**Goddard Space Flight Center  
Wallops Flight Facility  
Wallops Island, VA 23337**

## Meeting Minutes

Shoreline Restoration and Infrastructure Protection Program EIS

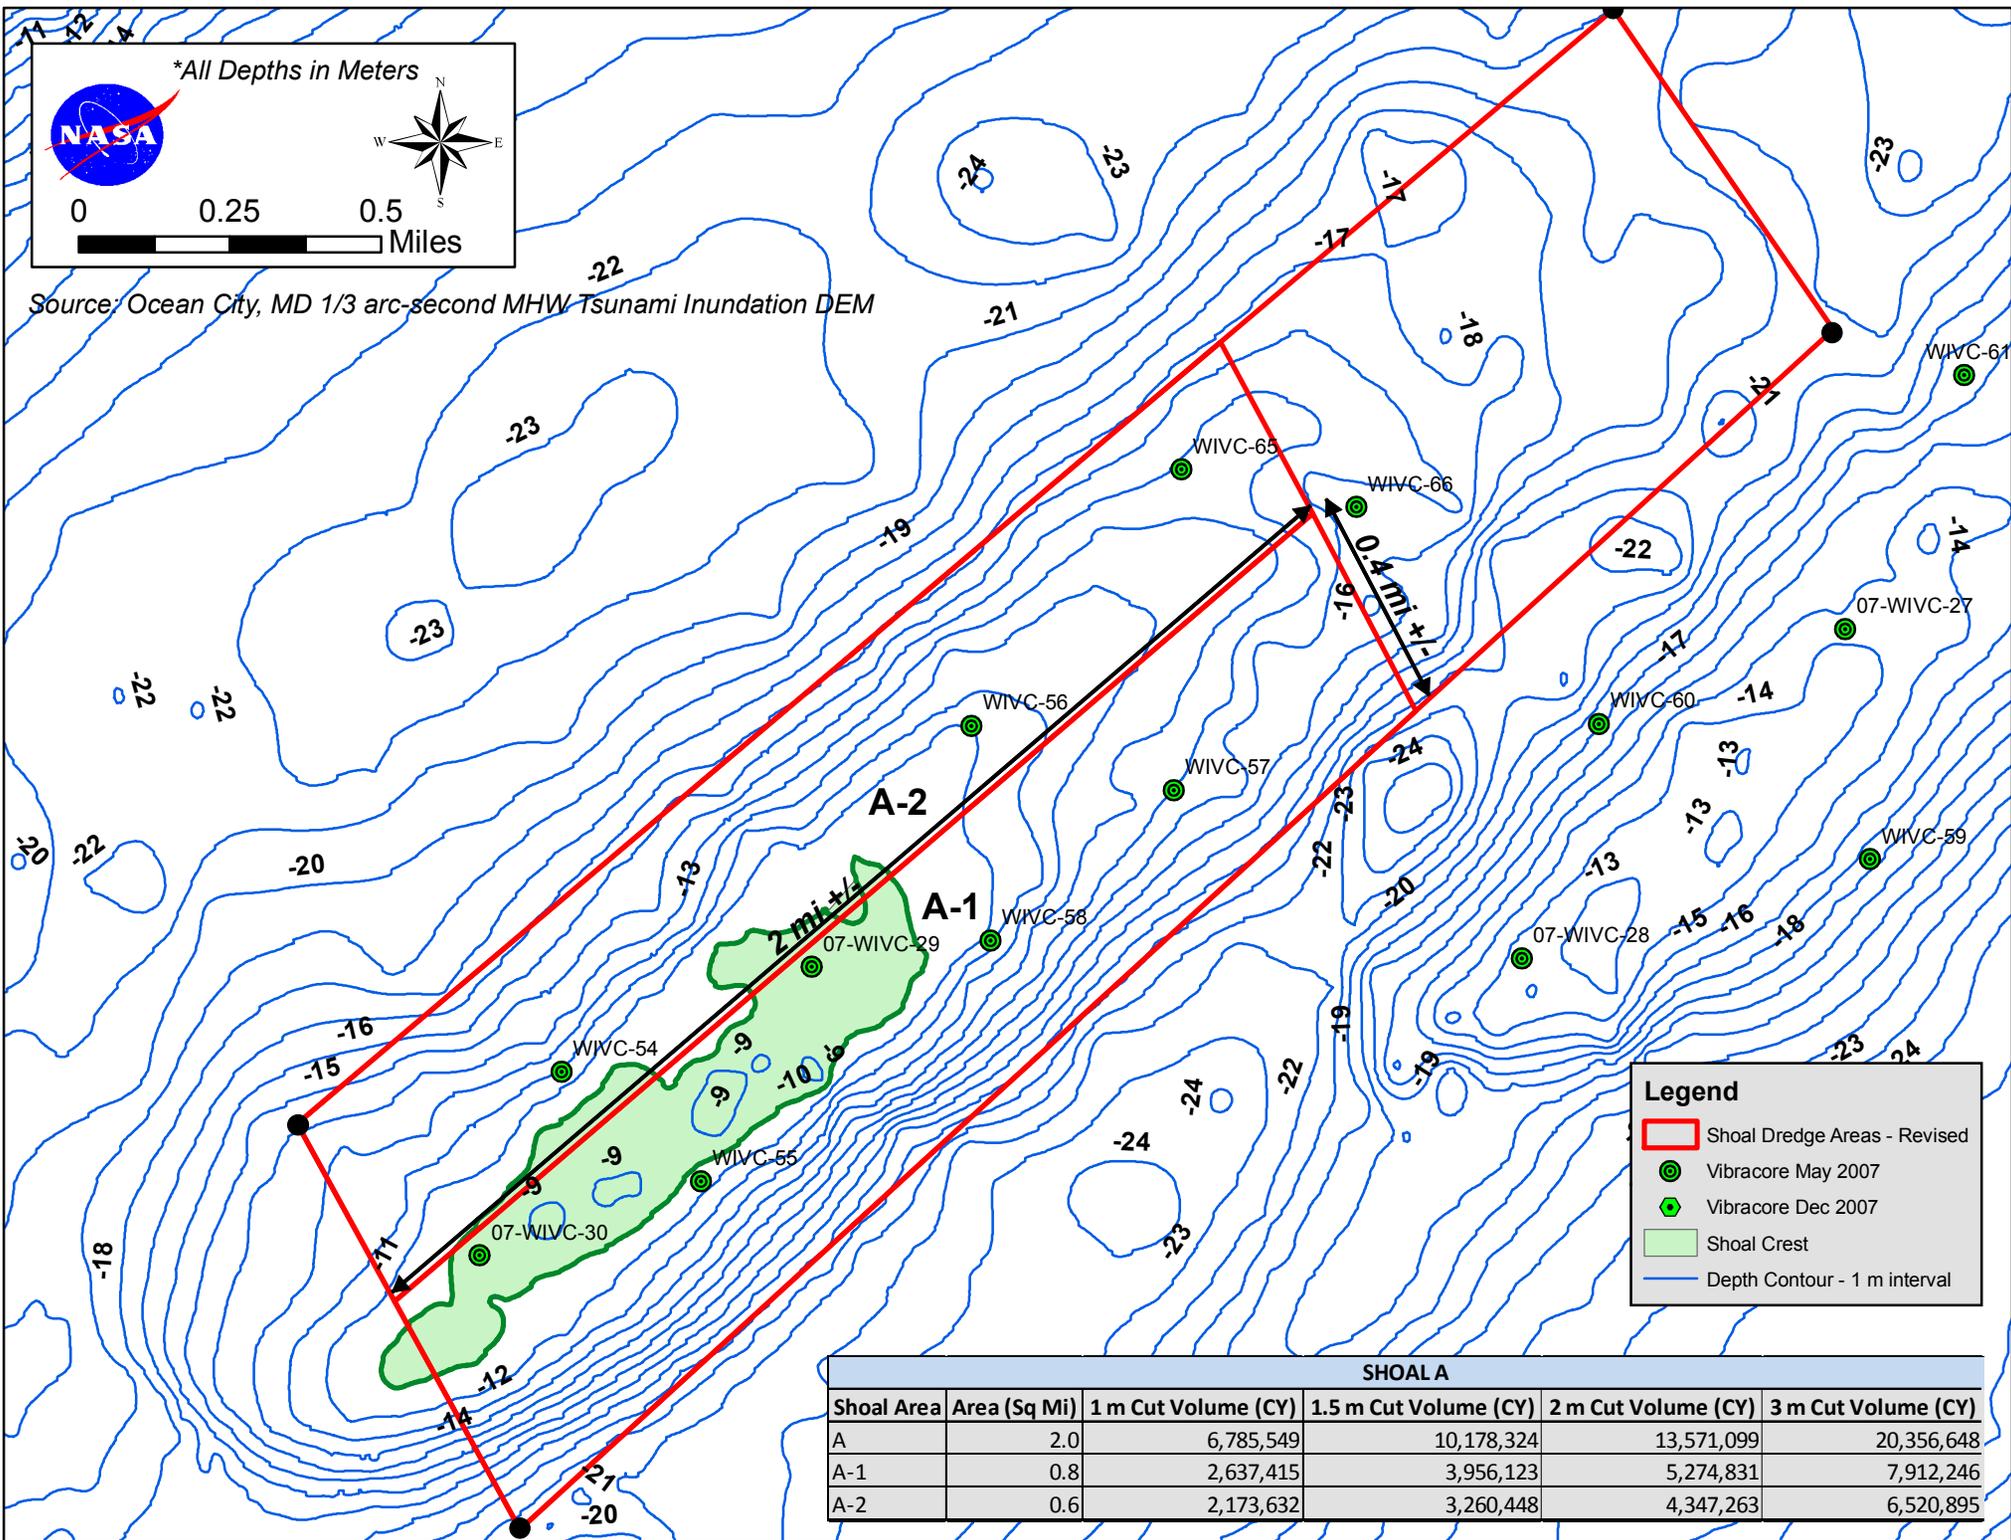
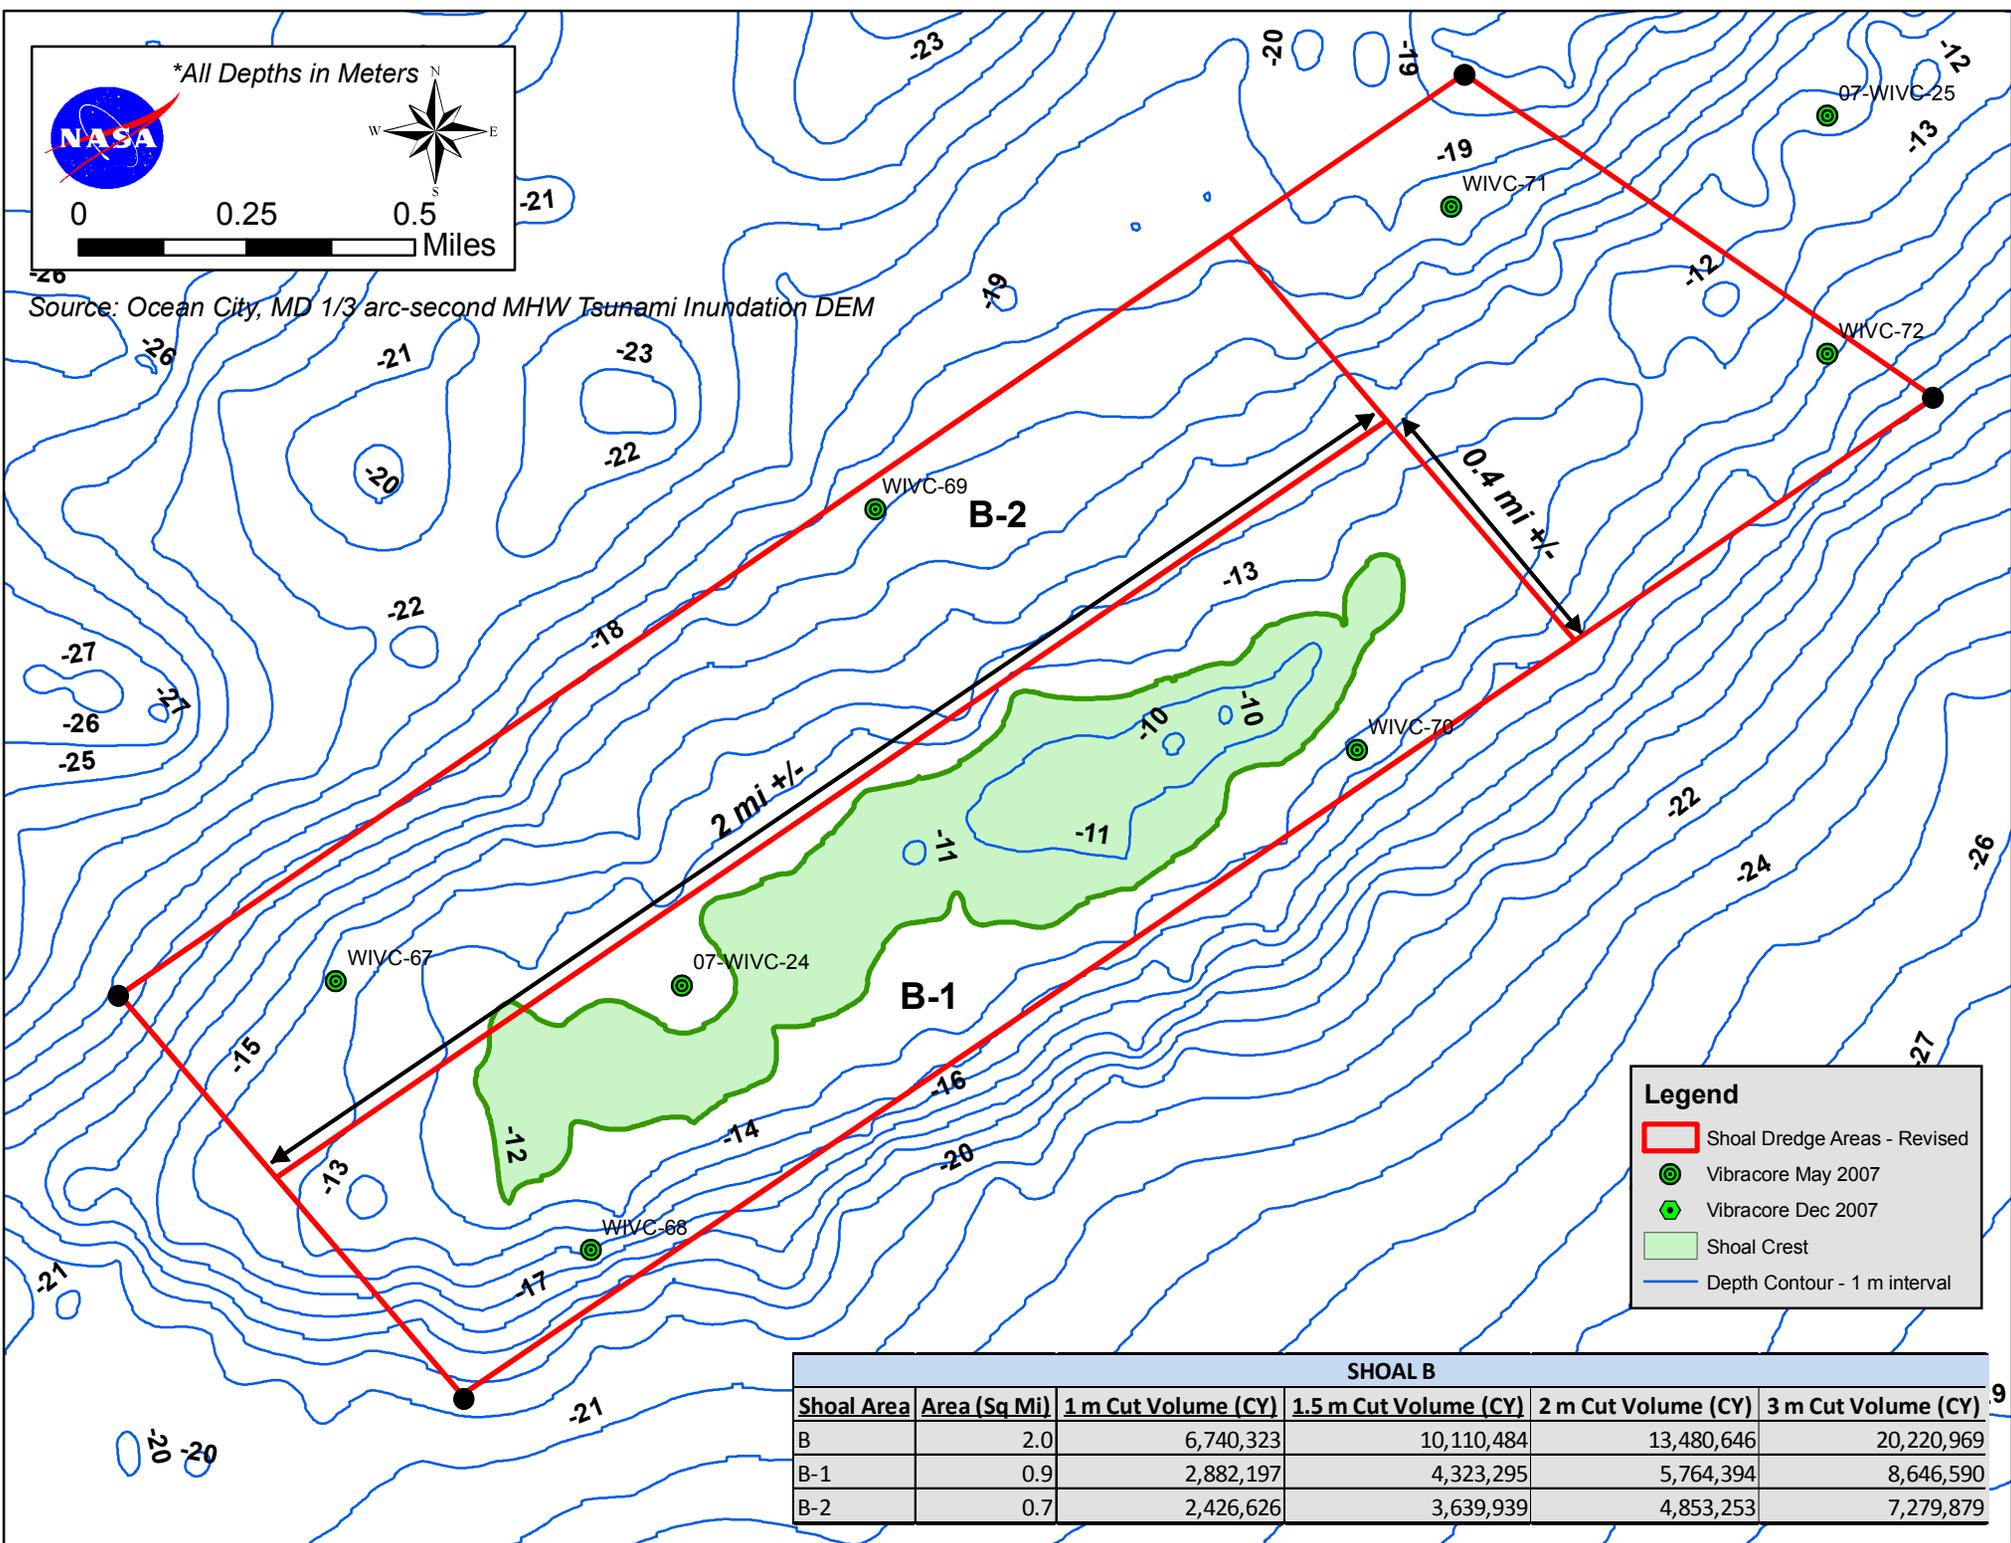
Attachments two and three depict borrow areas that do not differ much from what were proposed in your response letter of June 2010. For both shoals, you are borrowing along most of the long axis of the shoals, and borrowing from the entire crest. A portion of each shoal crest should be left intact (untouched) to allow for recovery of the crest to pre-existing elevations.

Figure 7.11 Dredging Scenario 3.

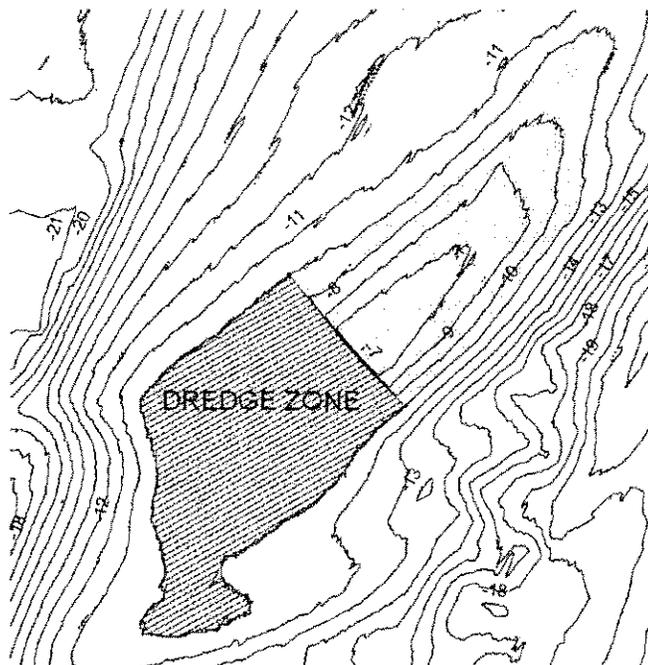
*The attached figure is from "Investigation of  
Judging Guidelines to Maintain & Protect the  
Integrity of Offshore Ricks & Shoal Regions"  
Dibajnia & Navin 2010 (draft)*

In this scenario the southwestern half of the crest of Isle of Wight is dredged to -10 m contour, as shown in Figure 7.11, to provide about 1.8 million m<sup>3</sup> of sand.

Figure 1: Bathymetric isopach for Shoal A (1933/34 to 1978/82). Maximum accretion within shoal footprint (black) and dredge area (red) is 6 m. Maximum erosion within shoal footprint (black) and dredge area (red) is 3 m.

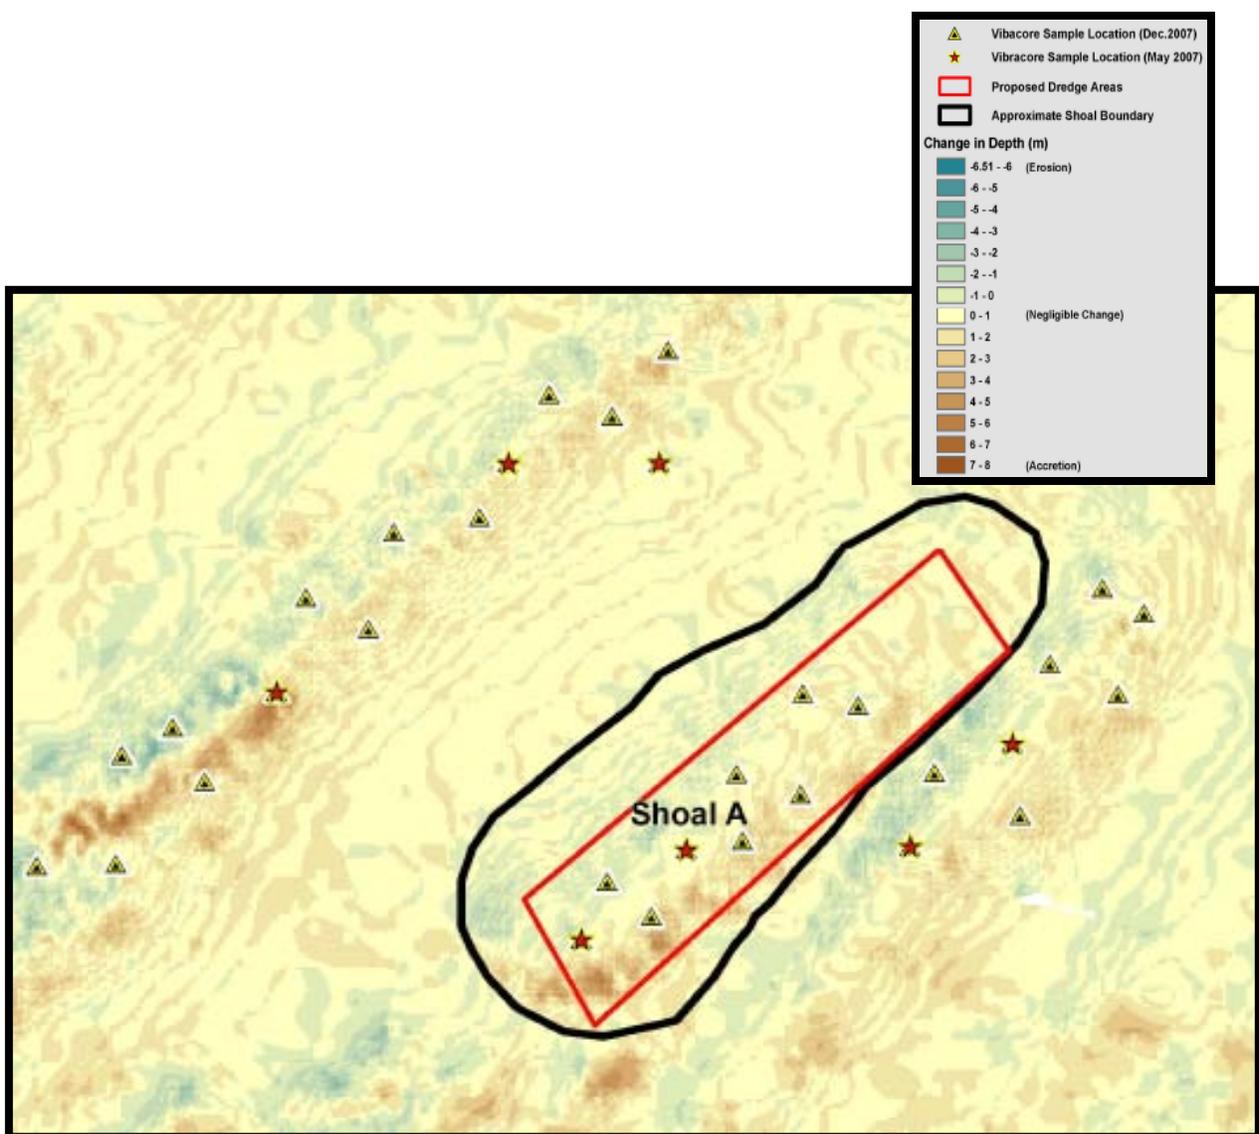
The eastern half of the entire longitudinal axis on SRIPP Shoal A is accretional over the time period 1933/4 to 1978/82 (Figure 1). The same trend is clearly seen in the shoal immediately west of SRIPP Shoal A. On IOW, the northeastern half of the shoal is erosional (Figure 2). The footprint and magnitude of long-term accretion on the southern terminus of SRIPP Shoal A and IOW are also different (Figures 1-2). The accretional footprint on IOW is larger and wraps further west/southwest. Between 1929 and 2002, IOW accreted a maximum of 3.5 m. SRIPP Shoal A accreted upwards of 4-6 m along its leading edge over a fifty year period.<sup>2</sup> The morphologic behavior of the leading edge shoal is an important factor in shoal crest height recovery. Over the inter-centennial timescale, IOW appears to better fit the wave-dominated shoal evolution paradigm of Hayes and Nairn (2004) on which most of the above recommendations are premised. It should also be noted that the principal patterns of morphologic change vary over shorter time scales (i.e., inter-centennial (Figure 2) vs. decadal (Figure 3)), as well as between adjacent shoals. A comparison of bathymetric change maps for ACM Shoal A, Weaver, and IOW shoals illustrates notable variability in physical behavior of the same time frame (Figures 3-5).

Figure 6: SRIPP Shoal A Dredge Areas

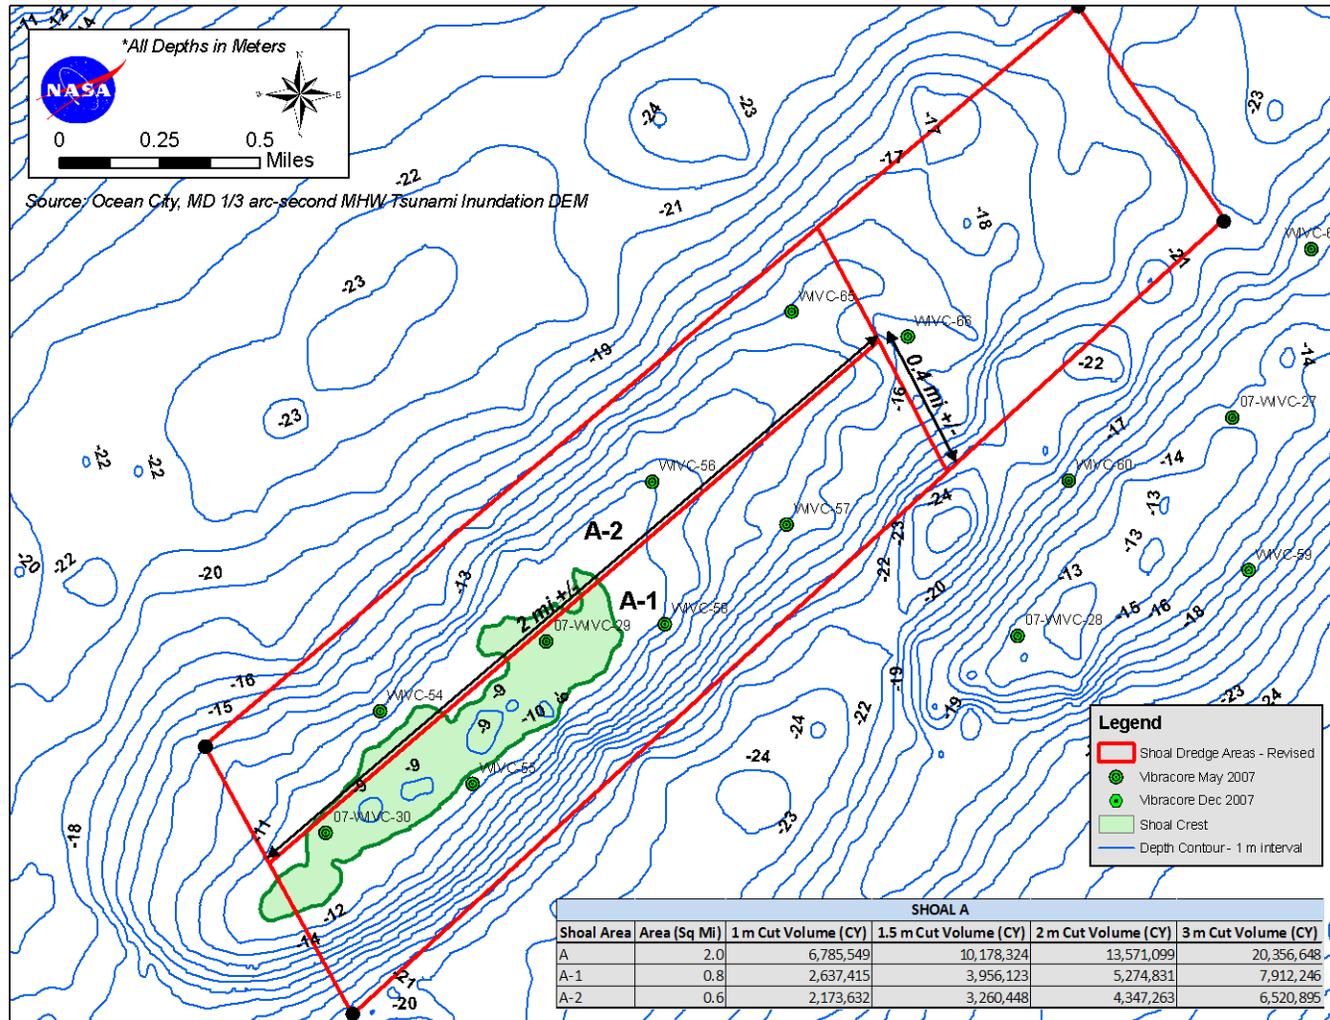
In conclusion, targeting Area A-1 shown on Figure 6 employing the methodology described in this document is NASA's final decision regarding how SRIPP Shoal A would be dredged for the initial fill cycle. Specifics regarding the use of either SRIPP Shoal A or B for renourishment would be considered in supplemental EFH consultation during the planning for that phase of the project.
